Amendments to the Drawings

Attachment: Replacement Sheets
Annotated Marked-Up Drawings

Docket Appl'n No.: 09/628,614
Title: Method and Apparatus for Storage and
Inventors: John Christopher Brock, et al.
Annotated Marked-Up Drawings

FIG. 5

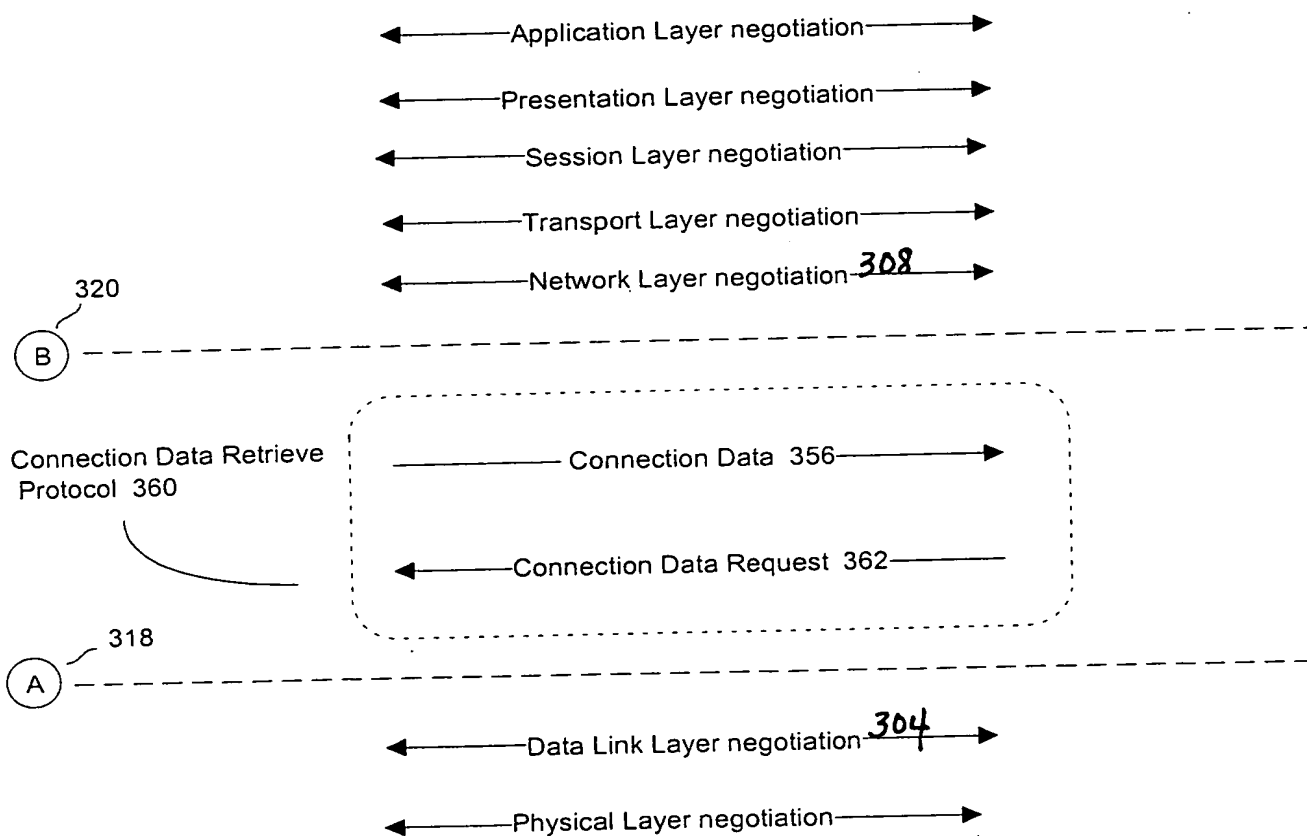
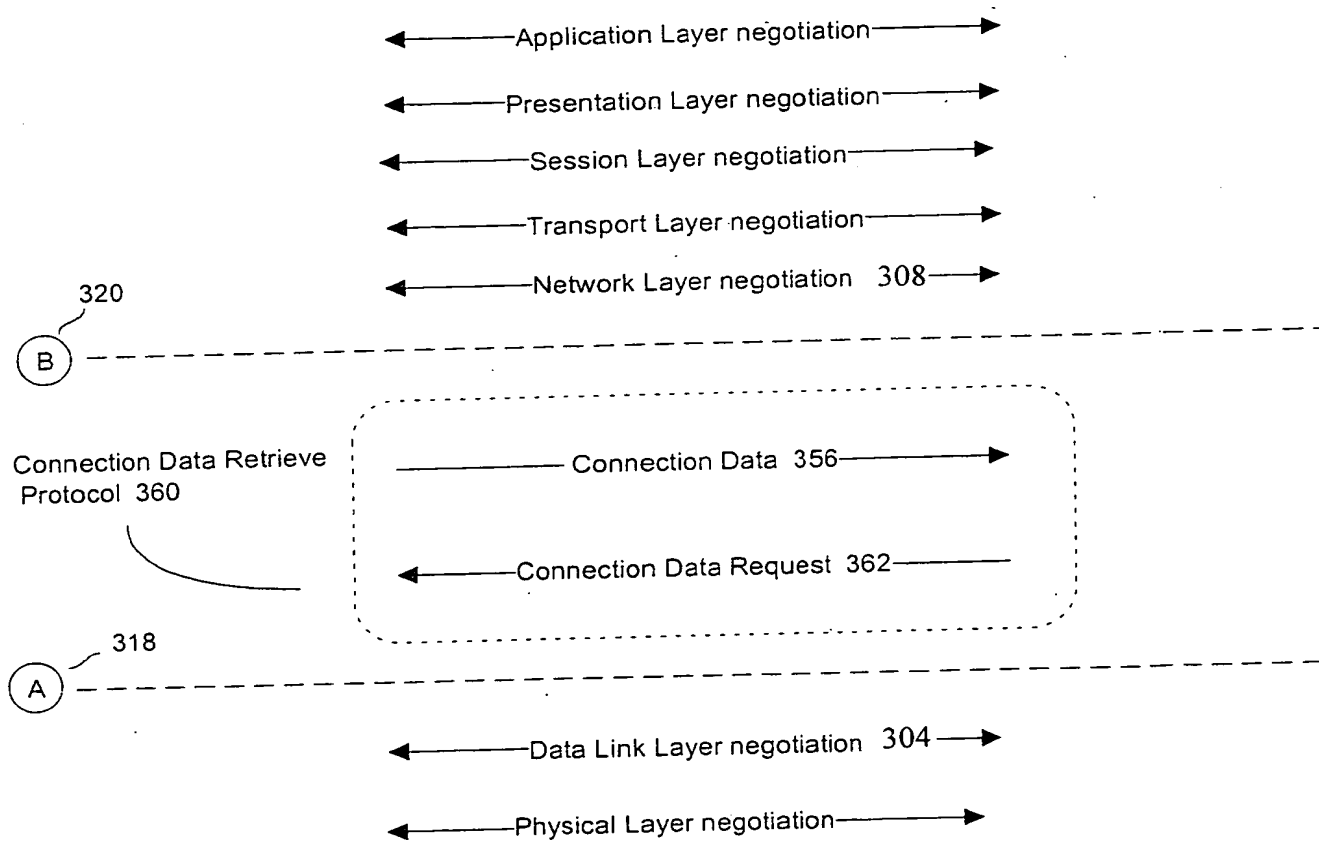
FIG. 5 is amended to add reference signs 304, 308 referred to in the specification. FIGs. 6 and 7 are amended to correct misspelled wording "Recieve". No new matter is added.
